Addendum 1

To: Frank King, King Valuation Co.	
From: HDR Alaska, Inc.	Project: South Wasilla Track Realignment
CC: Chris Anderson, Alaska Railroad Corporation (ARRC); Kristina Swanson, ARRC	
Date: 9-22-05	Job No: 09585-4566

RE: Ranch Subdivision Right-of-Way Impacts (Rev. 2)

Figure 1

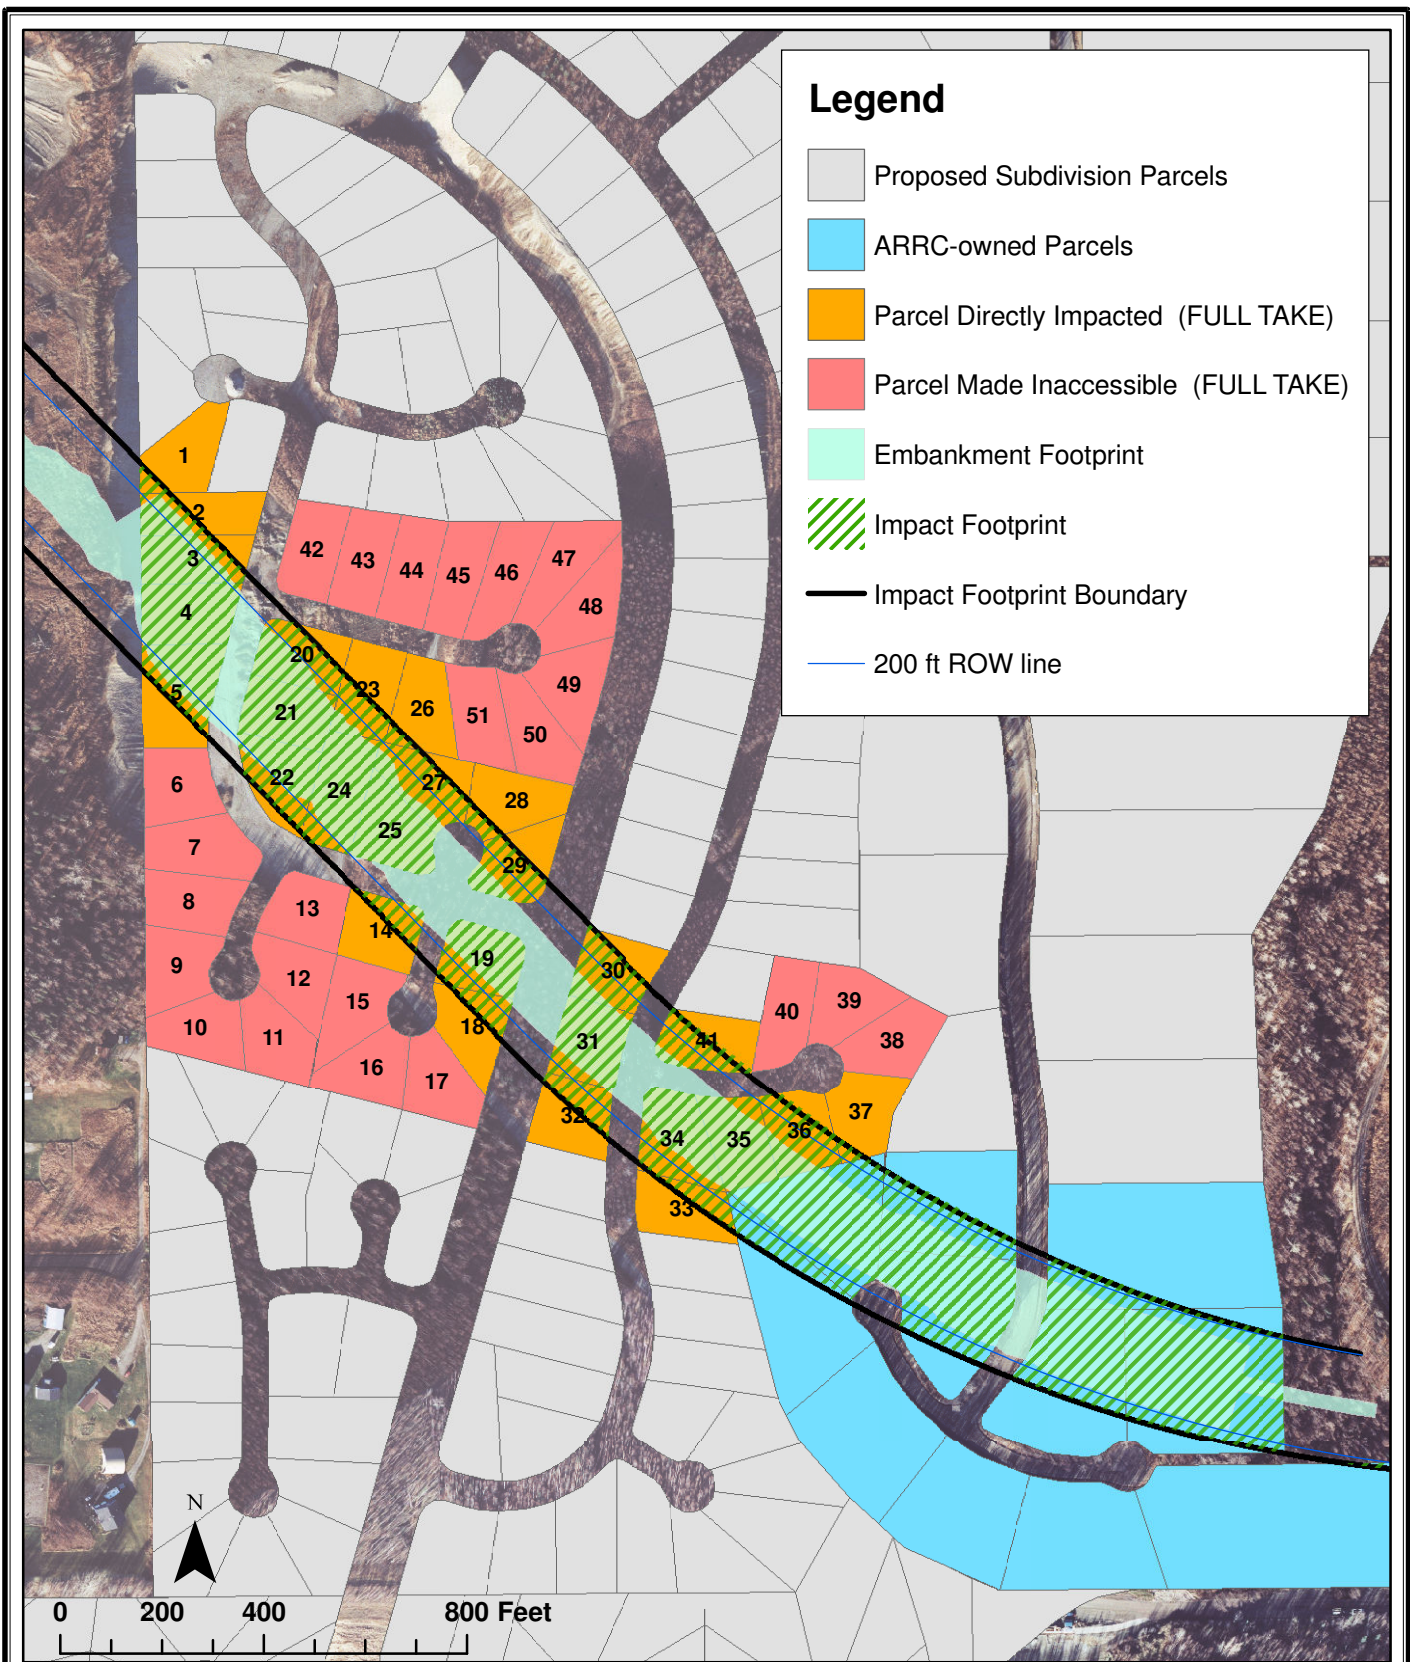
Memo Revision: This is the second revision to this memo. Originally, parcels 48, 49, 50, and 17 were originally assumed to be made accessible from the lot frontage facing the main street through the subdivision. However, through conversation between ARRC’s real estate appraiser and the Mat-Su Borough, the Borough said they do not want driveways facing this road because it would serve as an arterial road rather than a collector road, meaning the speed limit would be faster than the speed on a local, residential road. So these four parcels are no longer accessible.

Ranch Subdivision Impacts with No Mitigation: Under this option, it is assumed that the proposed subdivision parcel boundaries cannot be replatted and therefore must remain as currently drawn. Fifty-one parcels are impacted under this option and all 51 are assumed to be fully acquired. Of the 57 parcels, 27 parcels would be directly impacted by the ‘Impact Footprint’ and are assumed to be acquired in full. The remaining 24 parcels would be made inaccessible even though the impact footprint does not touch these parcels. See Figure 1.

Figure 2

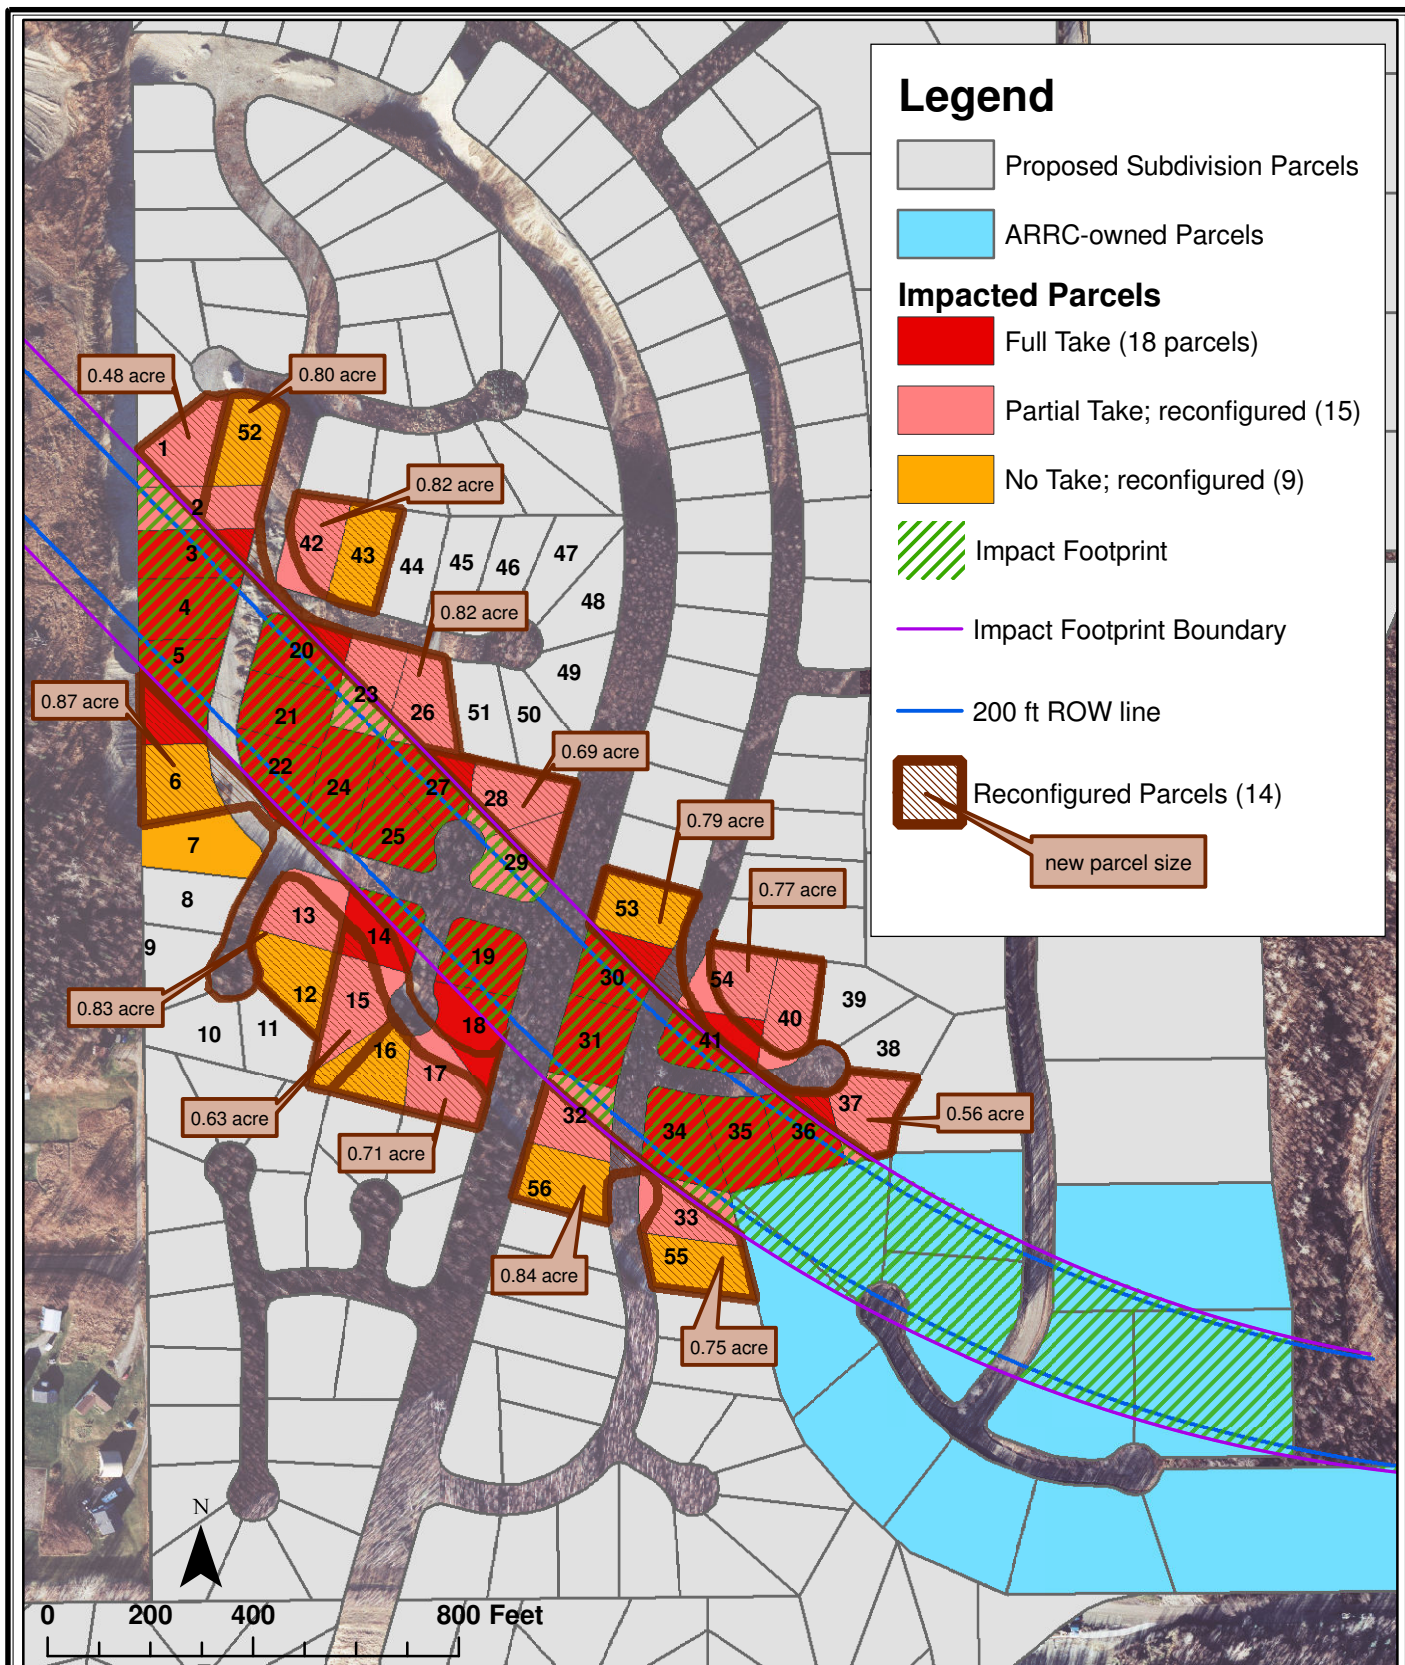
Ranch Subdivision Impacts with Possible Mitigation (Reconfigured roads and parcels): This option assumes that the proposed subdivision parcel boundaries can be replatted and the parcels and access roads reconfigured as mitigation so the least number of parcels are impacted. Forty-two parcels are impacted under this option. Out of the 42 parcels impacted, 18 parcels are assumed to be fully taken, and to mitigate for these, 14 parcels would be reconfigured and are assumed to be made usable for potential development (as depicted on the corresponding figure, Figure 2). The required parcel ‘take’ is broken down into the following:

Fourteen parcels (parcels 8, 9, 10, 11, 38, 39, 44-51) that were made inaccessible under the no mitigation option are now made accessible with the road and parcel reconfiguration as proposed with the mitigation option. The 14 parcels that would be reconfigured and are assumed to be usable for potential development range in acreage from 0.48 acre to 0.87 acre, slightly larger in acreage than what is currently platted.
